To: All Plan Holders of Record

Re: *Addendum No. 1*
Lake County Executive Airport Terminal
Lake Development Authority

Date: June 17, 2024

SCALE:	As indicated
CONTRACT NO:	220656
SHEET	G0.12

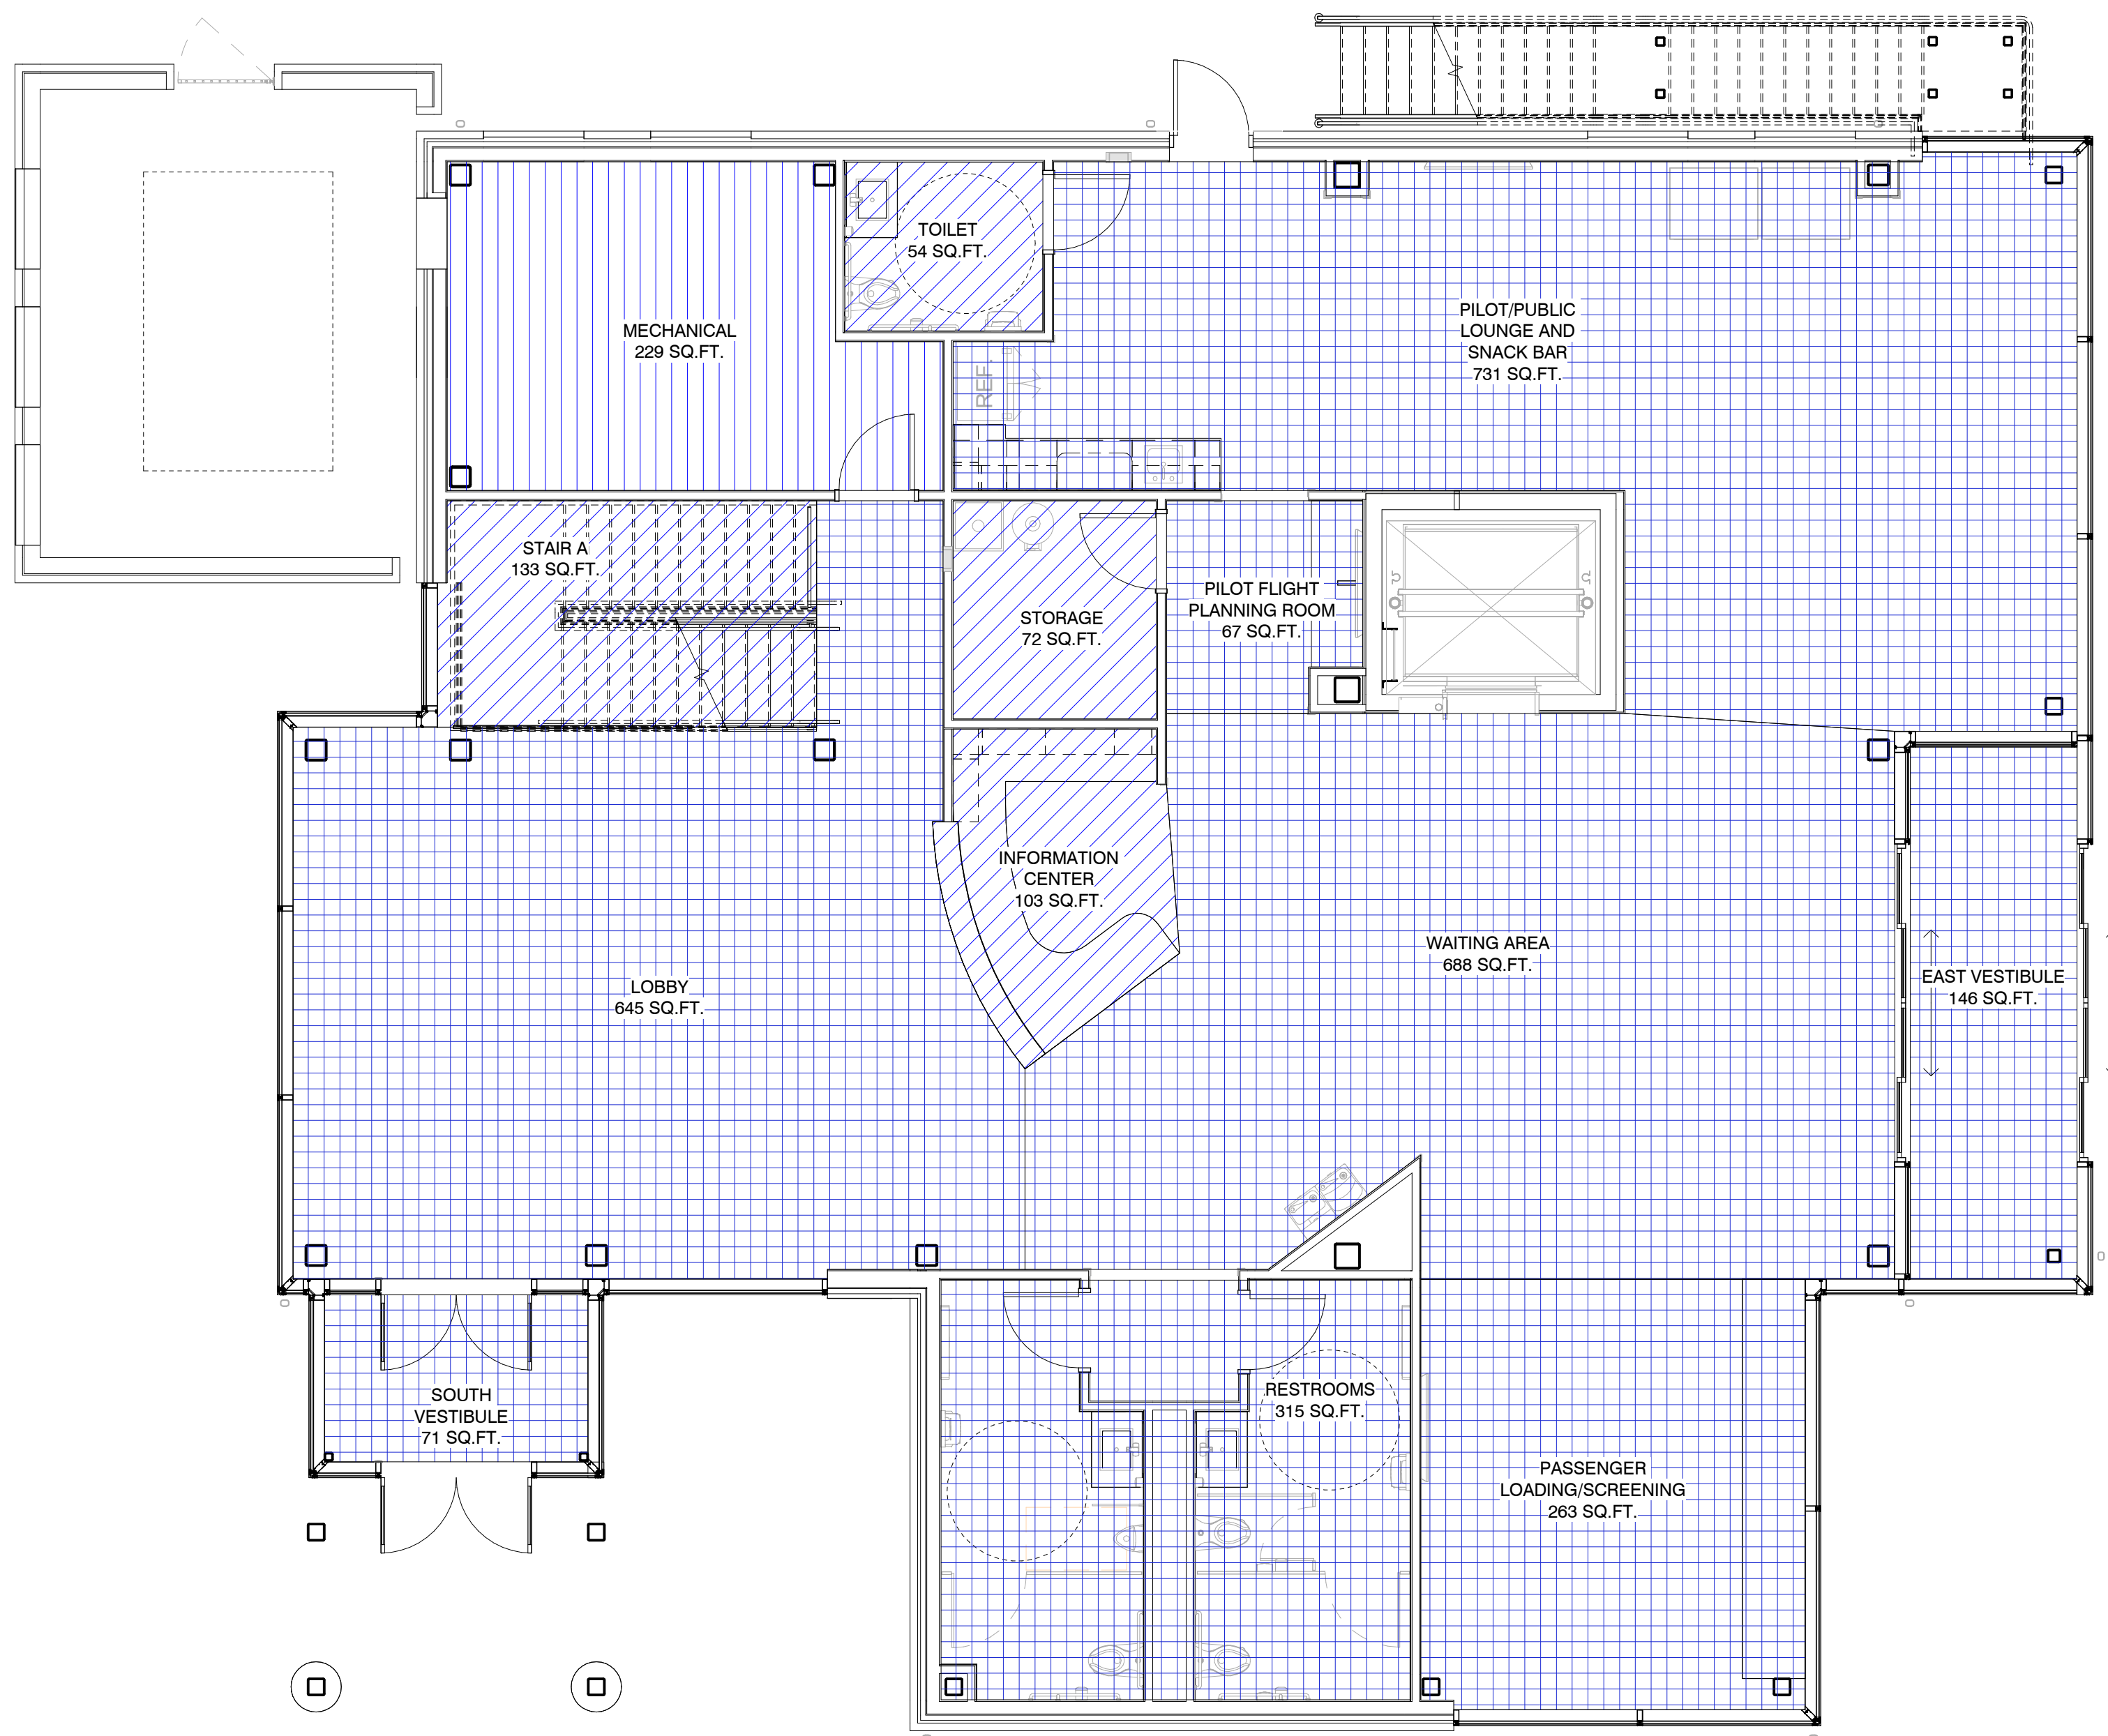
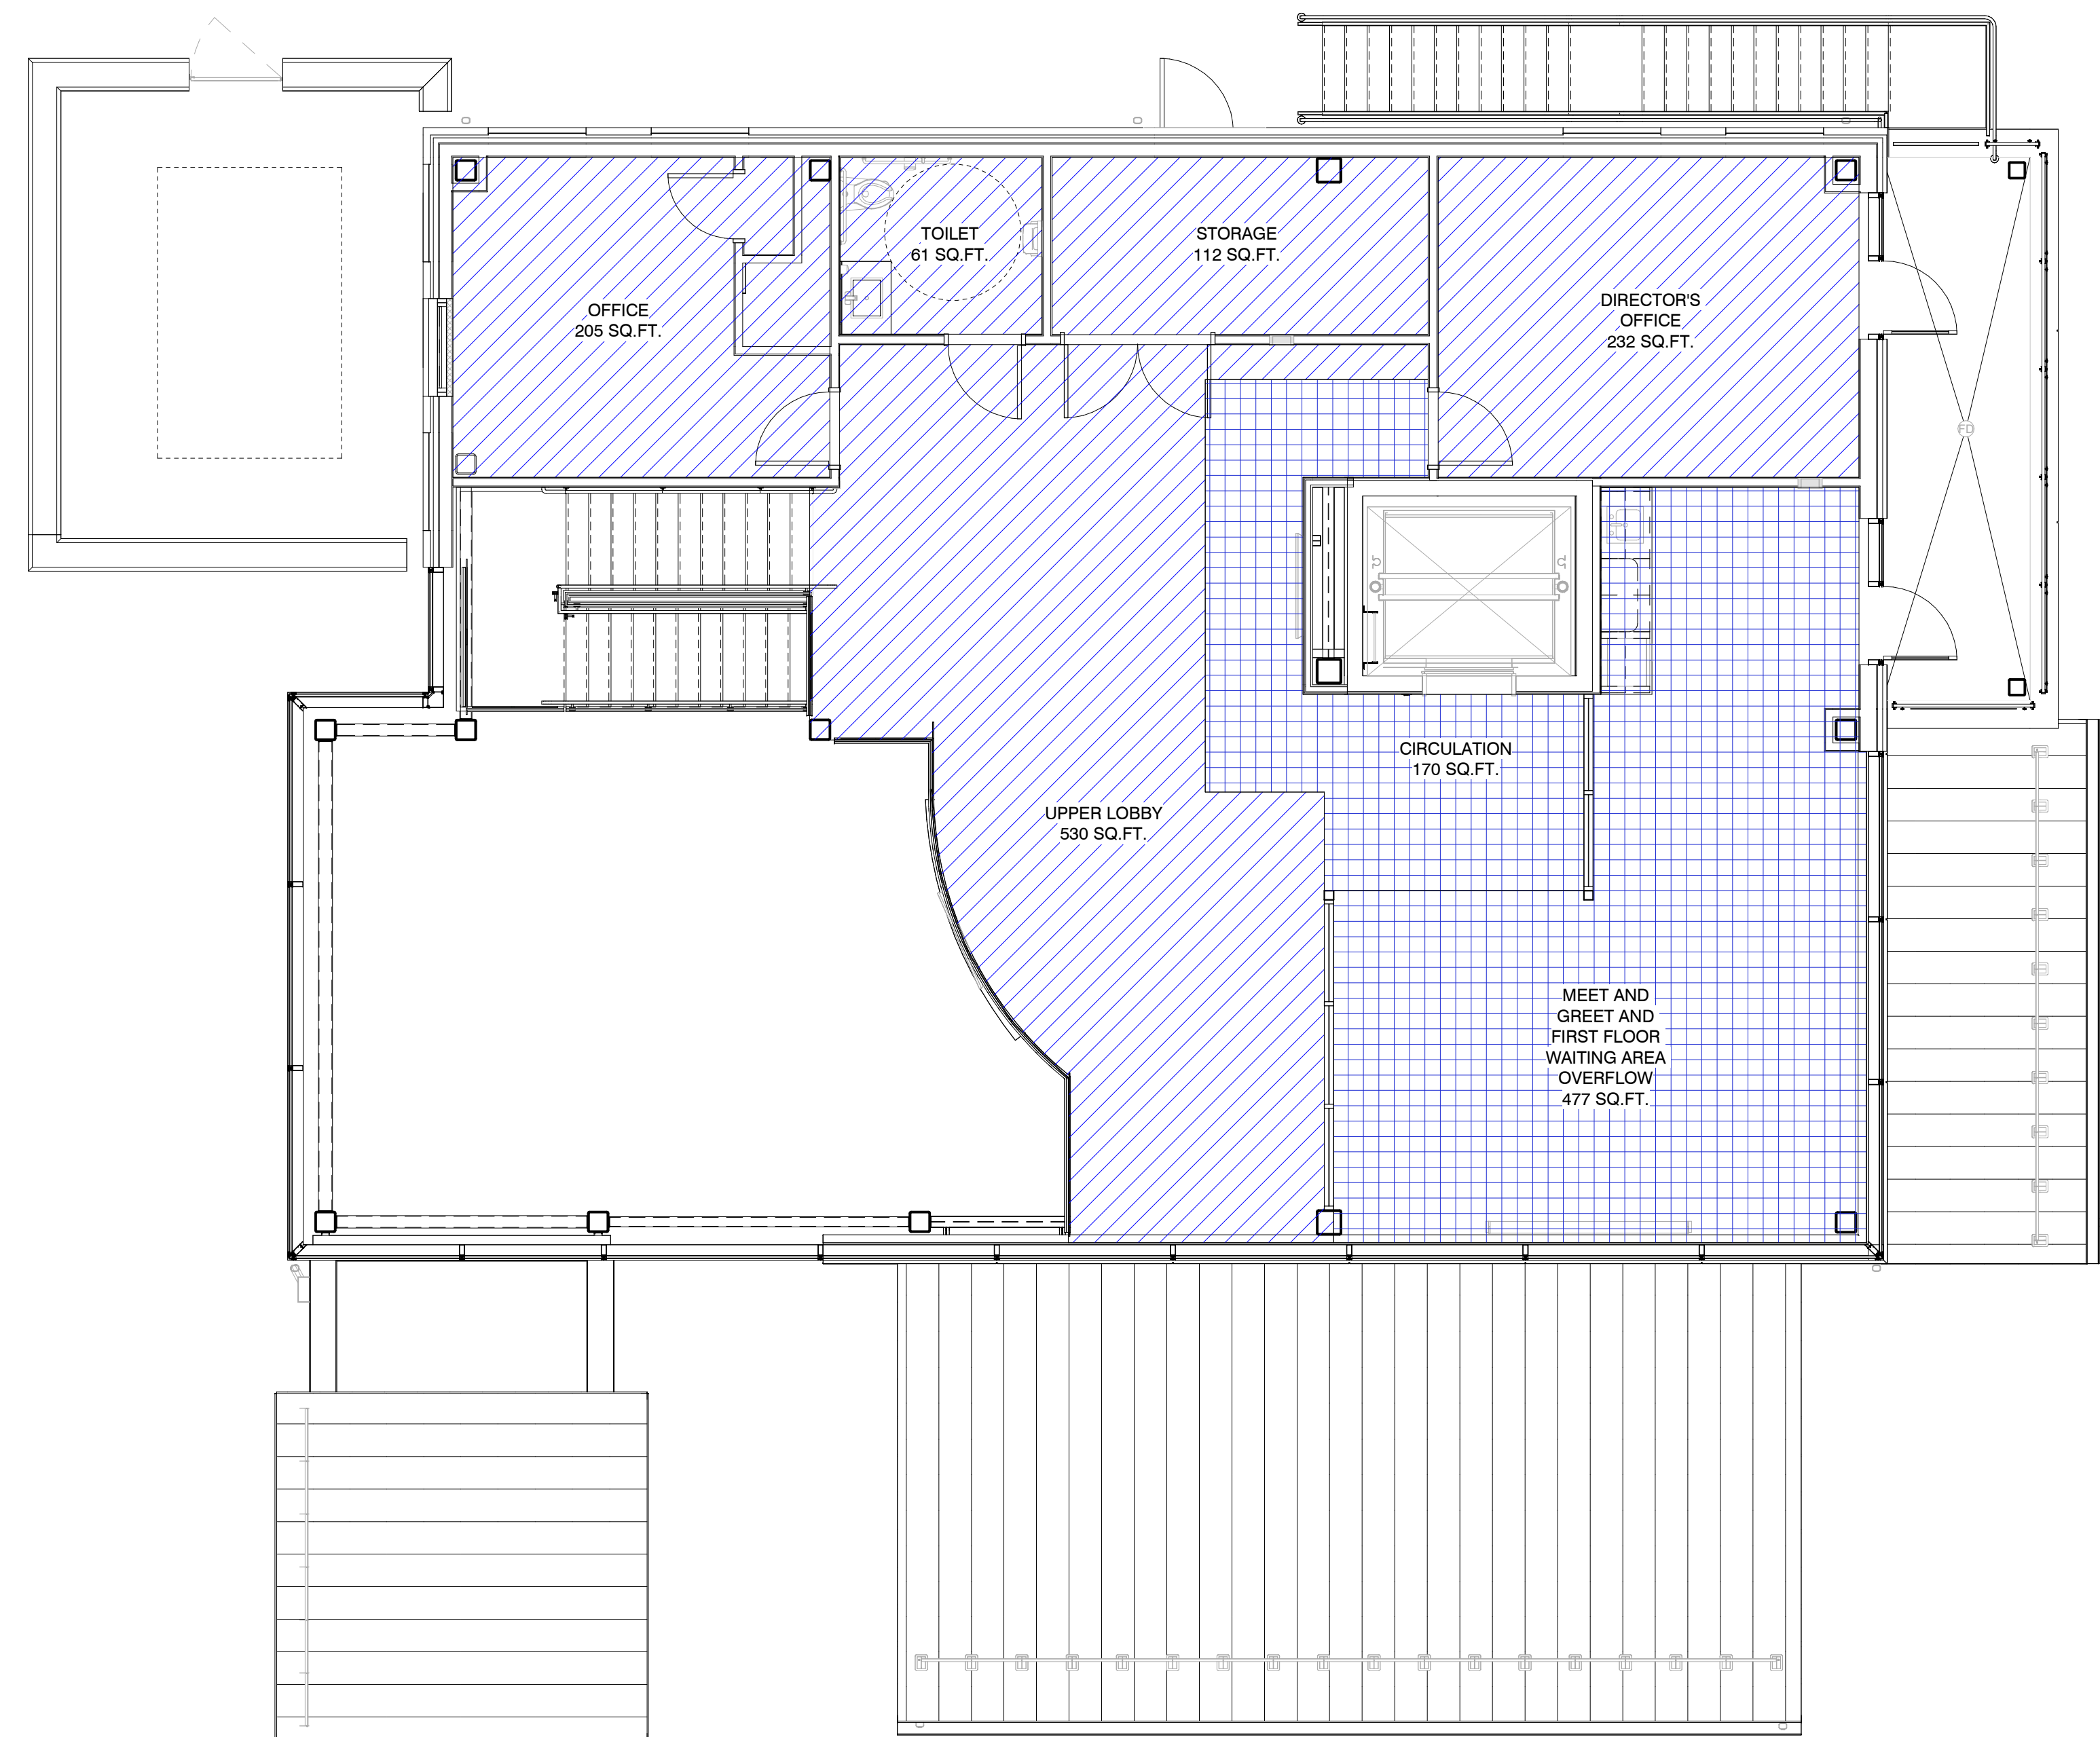
Added: Drawing Sheet G0.12: FAA Eligibility Floor Plans: Required by FAA.

SCALE:	As indicated
CONTRACT NO.:	220656
SHEET	S-1.2

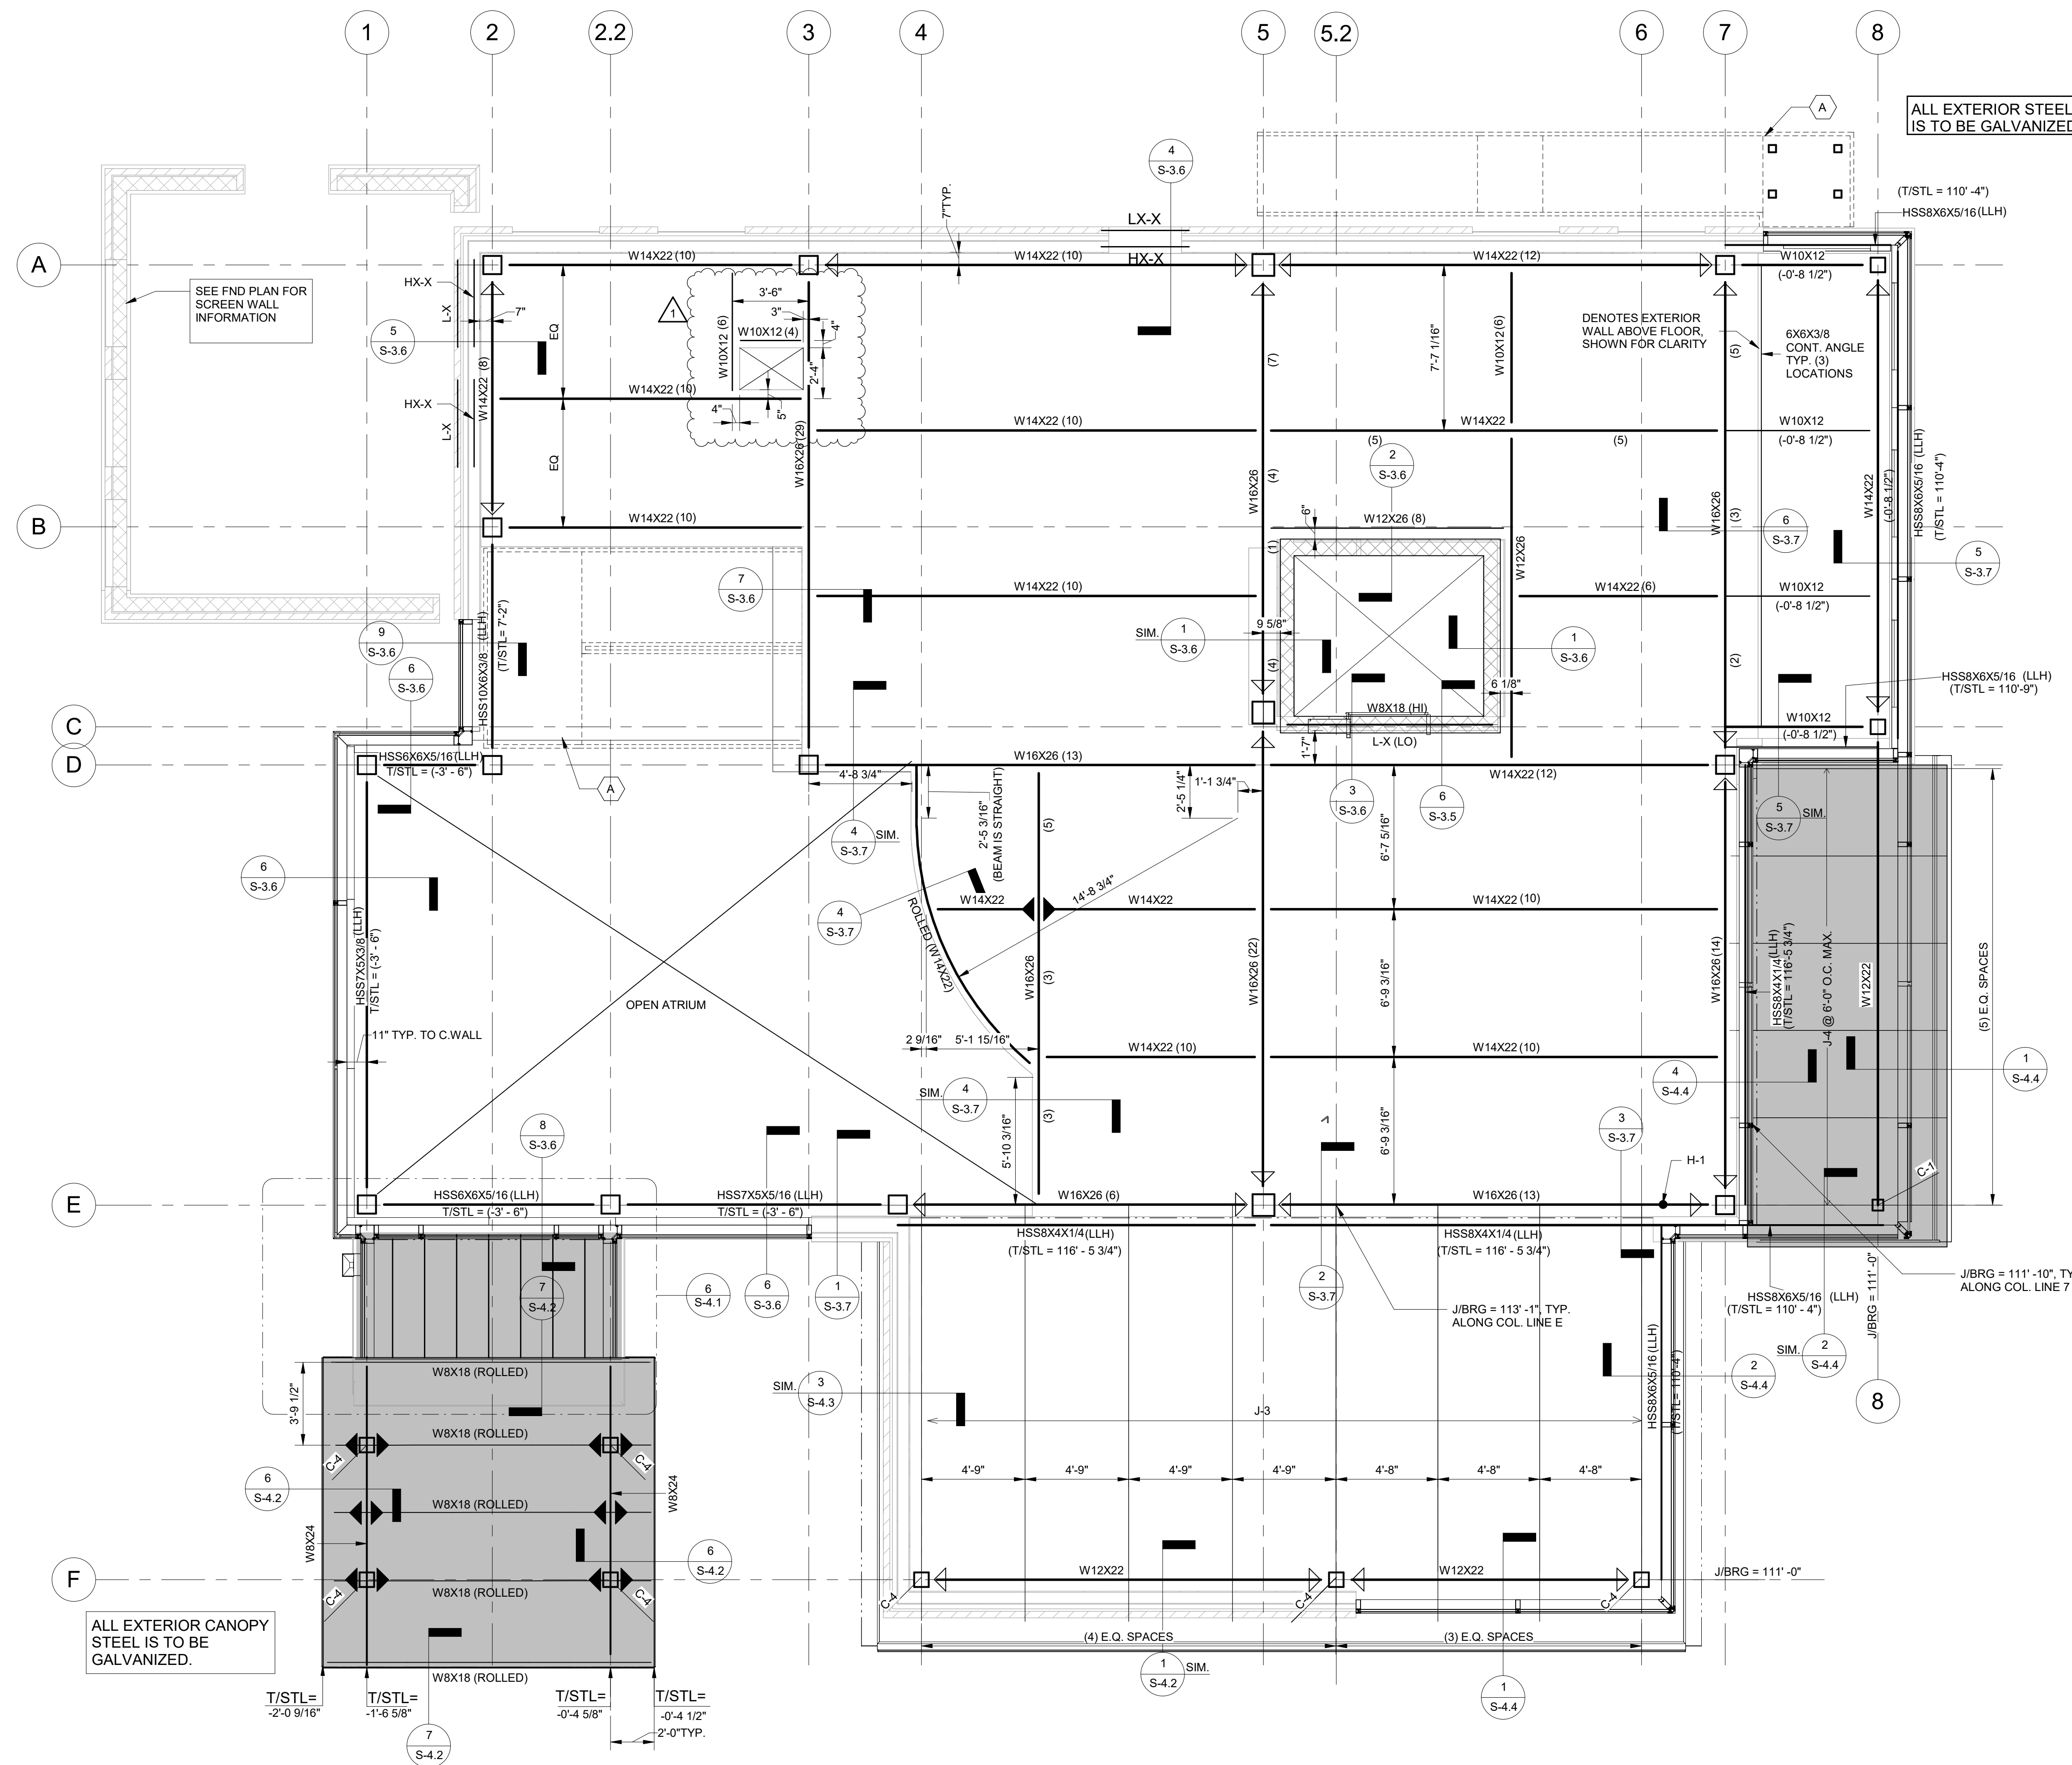
Reissued: S1.2. Updated steel framing to allow for HVAC floor penetration.

20. M1.01 shows a duct up to second floor at mechanical room 109. S1.2 floor framing plan does not show opening in second floor for this. Can this be added along with framing details for opening.

Response: See typical opening framing detail on S3-1. Coordinate exact location with Mechanical Contractor.
